SUBJECT: Forwards proprietary response to RAI re structural aspects of spent fuel pool storage rack mod at Ginna Nuclear Power Plant. Proprietary response withheld (ref 10CFR2.790).

Subject: Response to Request for Additional Information on the Structural Aspects of the Spent Fuel Pool Storage Rack Modification at Ginna Nuclear Power Plant (TAC No. M95759)

Figure NRCQ1b.1 PSD Comparison For GINNA SSE1 - Horizontal X

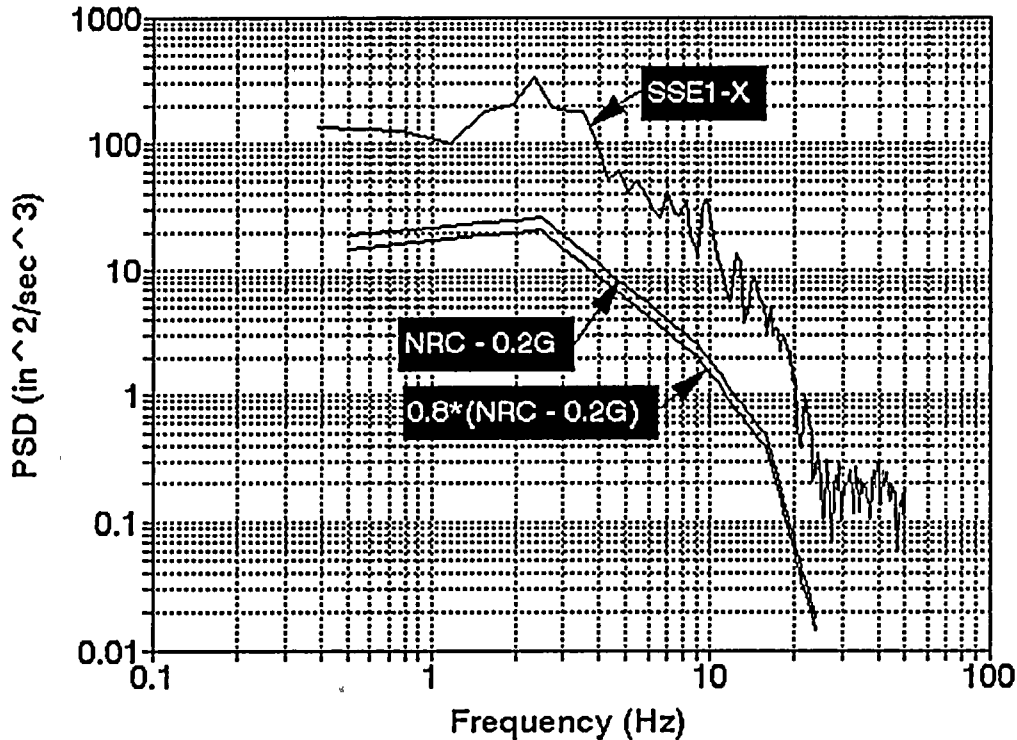
*In the staff's RAI dated September 5, 1997, you were requested to provide a power spectral density (PSD) of the artificial time history to demonstrate the adequacy of the time history. You provided a PSD of the time history (SSE1-X) with a PSD function developed from Regulatory Guide (RG) 1.60 spectrum (NRC-0.2G shown on page A-8 of Reference 1). It is interesting to note that the SSE1-X PSD contains energy that is more than about 1.4 to 1.8 times the energy of the NRC-0.2G PSD. RG&E is requested to provide the following:*

- (a) Technical discussion of the details as to how the NRC-0.2G PSD was developed. Also, provide sample calculations.*
- (b) The time histories used for the development of the two (SSE1-X and NRC-0.2G) PSD on a 3.5-inch diskette.*
- (c) A comparison between the response spectra (RS) developed using the two time histories indicated in item (b) above.*

- a) The NRC-0.2G PSD scaled target curve (for example SSE-1 Horizontal X, Fig.NRCQ1b.1 in Reference B) is obtained as follows:

The target PSD curve scaling factor is  $(0.2)^2 = 0.04$ , since the SSE-X1 DRS peak acceleration is 0.2 G. For example, at  $f = 2.5$  Hz, the target PSD (based on 1.0G peak acceleration) is  $650 [\text{in}^2/\text{sec}^3]$ . The resulting scaled target PSD value for GINNA (using

the scaling factor = 0.04) then becomes  $0.04(650) = 26$  [ $\text{in}^2/\text{sec}^3$ ] in Ref. B, Fig. NRCQ1b.1. A similar procedure is applied for all other frequencies that define the GINNA scaled target PSD curve.

The 80% scaled target PSD curve is labeled as "0.8\*(NRC-0.2G)" in Ref. B, Fig. NRCQ1b.1, and represents 80% of the "NRC-0.2G" curve in the respective Figure.

- Notes: 1) Upper curve (SSE1-X) is the PSD for the GINNA time history SSE1-X.
- 2) Middle curve (NRC-0.2G) is the scaled target PSD curve, based on SRP 3.7.1 requirements. The scale factor is  $(0.2)^2 = .04$ . Therefore, at 2.5 Hz, SRP 3.7.1 specifies  $650 \text{ inch}^2/\text{sec}^3$ . The scaled target value at 2.5 Hz is  $(.04)(650) = 26 \text{ in}^2/\text{sec}^3$ . Note that this curve is not based on any time history.
- 3) Bottom curve represents 80% of the middle curve in 2) above. This is the minimum value specified by SRP 3.7.1.
